**Addendum No. 2  
to the Bidding Documents**

**State Project No. 117-161  
Federal Aid Project No. PEDS(227)**

**Branchville TOD Pedestrian Improvements  
Town of Ridgefield**

**September 12, 2022**

S-101

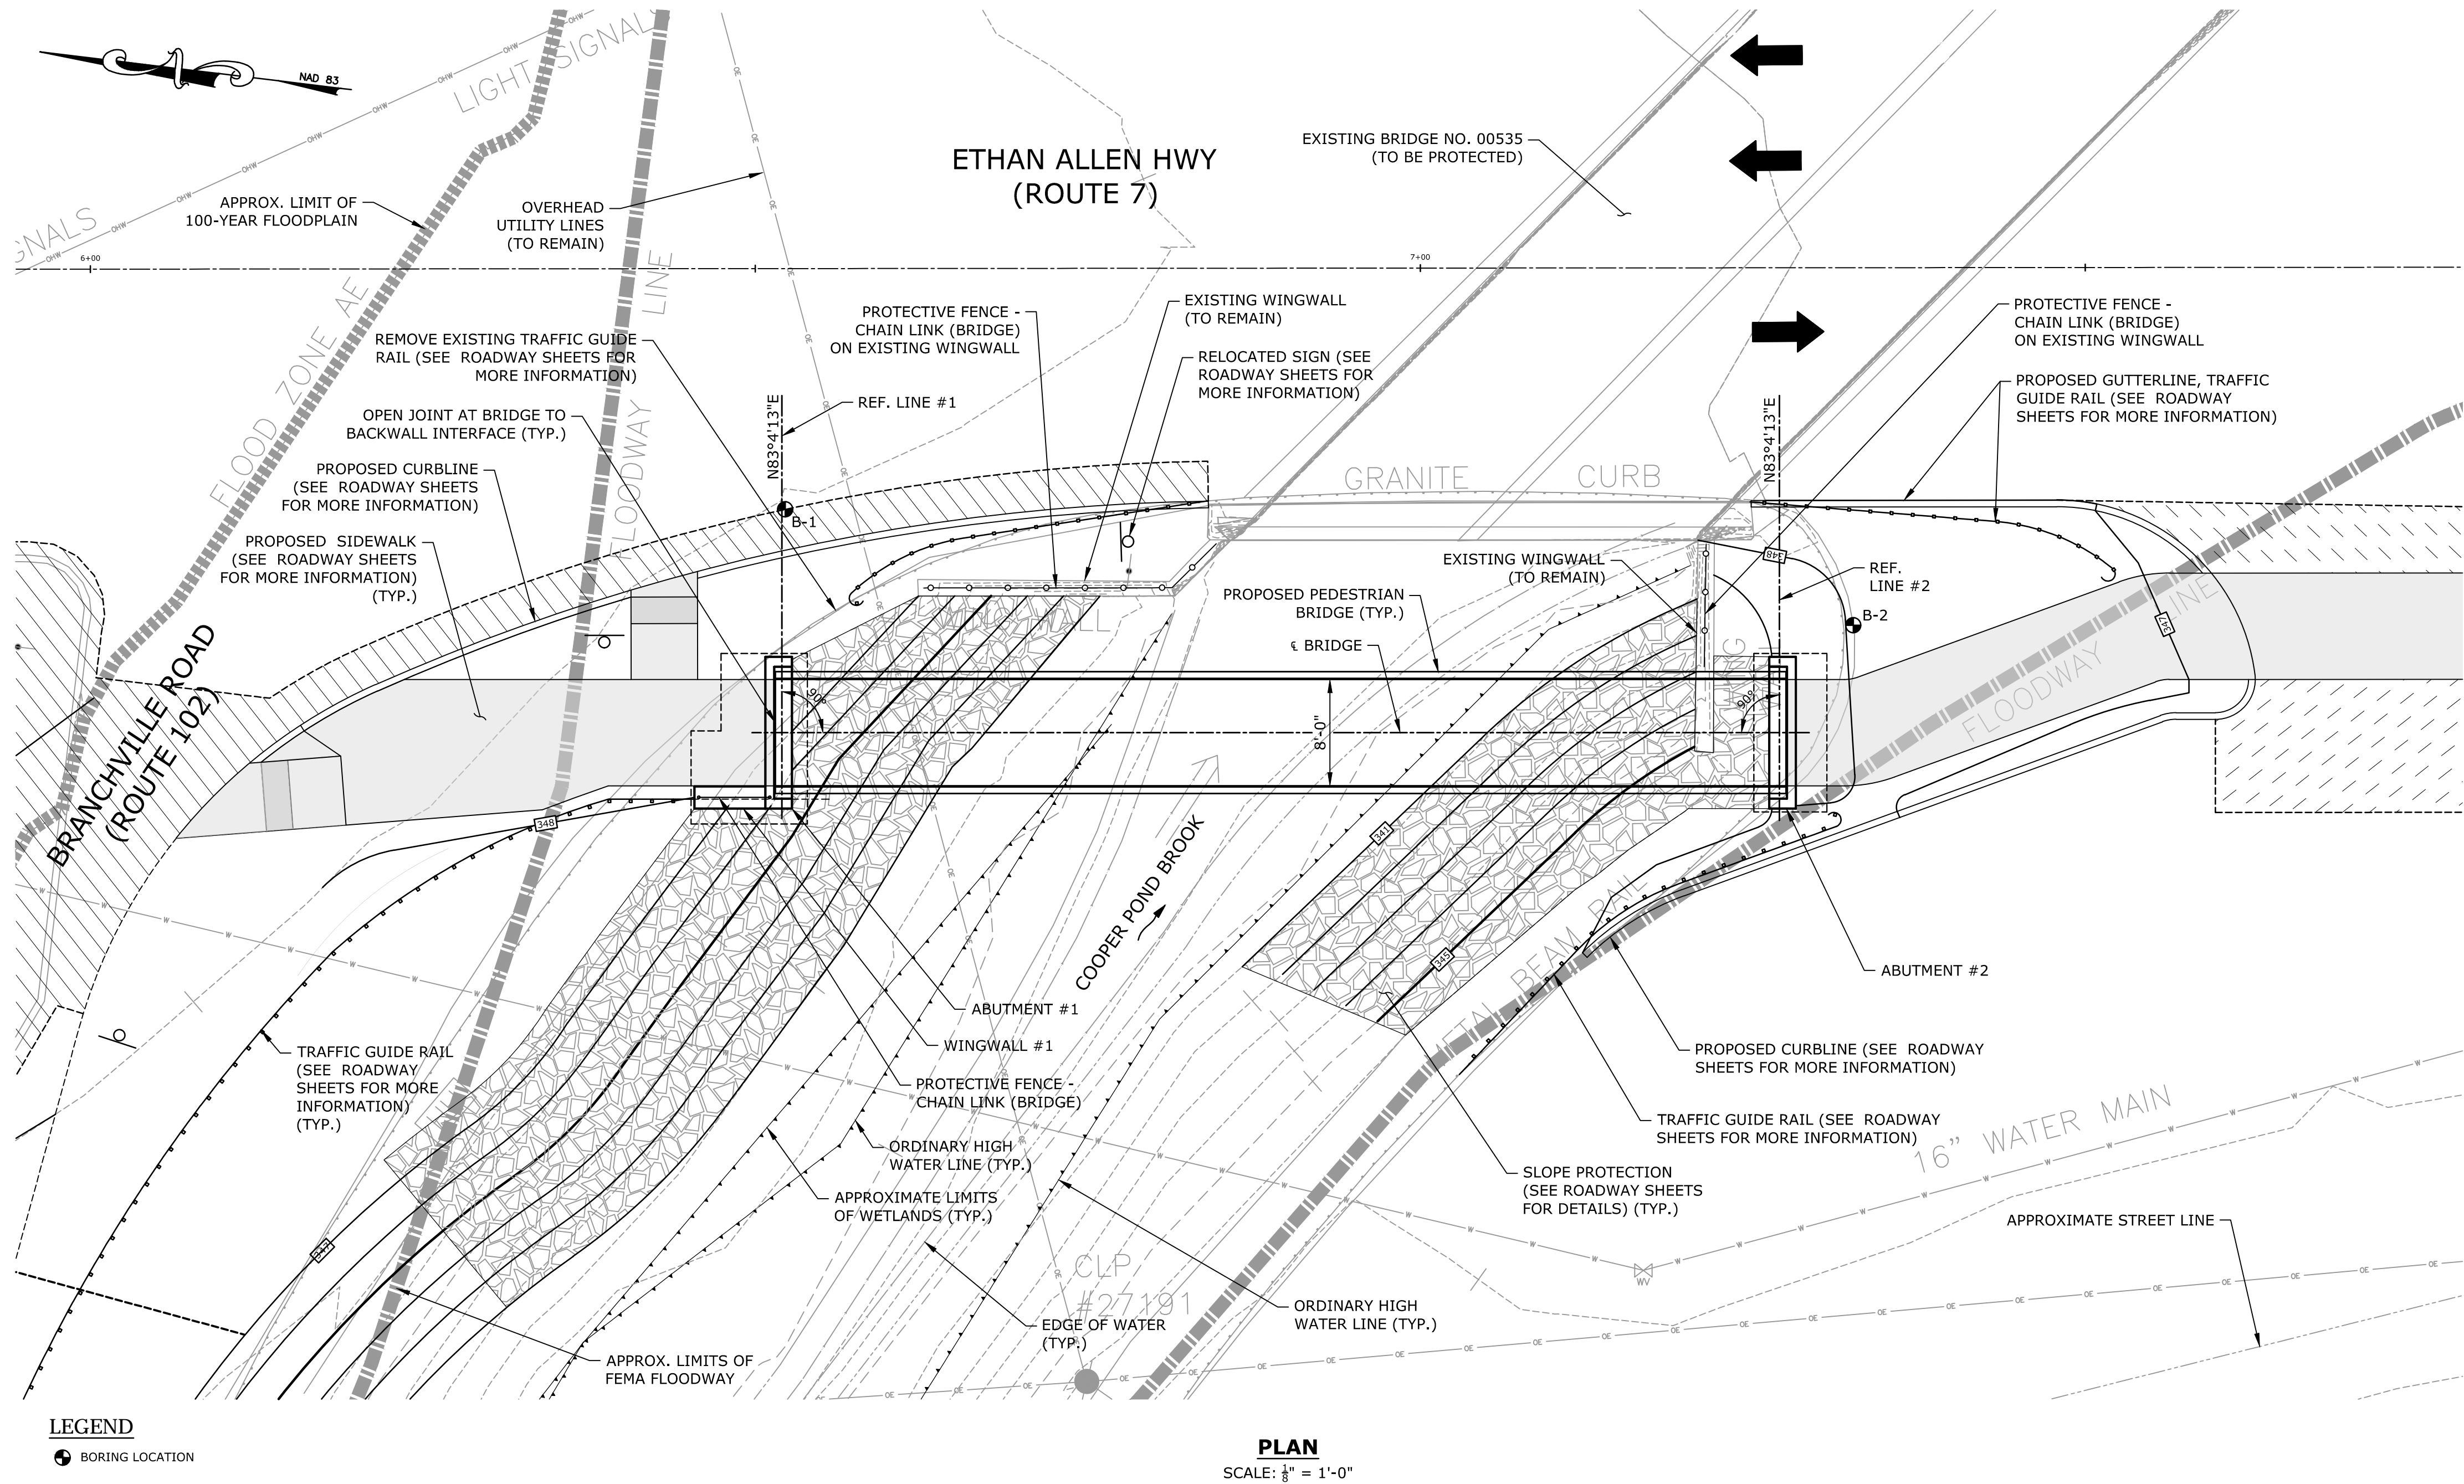
#### **Item 1      Drawing S-101, Material Strengths Notes:**

**Within the Structural Steel Section, Delete** "AASHTO M270, Grade 50WT2"

#### **Item 2      Drawing S-101, Live Load Notes:**

**Add** "(\*See Special Provisions)" to Live Load under General Notes.

- 4. Sheet S101 indicates that only AASHTO M270, Grade 50WT2 Steel will be allowed for the pedestrian bridge, while the specification requires ASTM A606 Type 4. Weathering steel HSS members are not produced in these ASTM designations. Weathering steel HSS members are produced in ASTM A847. Additionally, most weathering steel plate and shape products are stocked by industry producers in ASTM A588 or A709-50W. Are these material substitutions acceptable considering the structure is to be weathering steel?**

- 6. The pedestrian bridge floor beams are to avoid the existing wingwall to remain near Abutment 2. As shown the first floor beam is to be located in front of this wingwall, however is it OK to overspan existing wingwall if we can accommodate a great enough bay spacing? If so, what is the dimension of the wingwall along the length of the bridge so that we can make this determination?**

**And, within the Structural Steel section replace the deleted text** with "(HSS) ASTM A847, Grade 50W" & "(Plates & Shapes) ASTM A709, Grade 50W"

*No exceptions are taken to these ASTM material substitutions. Please see revised Special Provision #0604301A – Pedestrian Bridge Superstructure (Site No. 1) and revised Drawing S-101 attached.*

*Floor beams should be spaced to avoid the existing wingwall stem as noted in call-out in Elevation View on S-101. The existing wingwall stem is approximately 1'-3" wide at the top.*
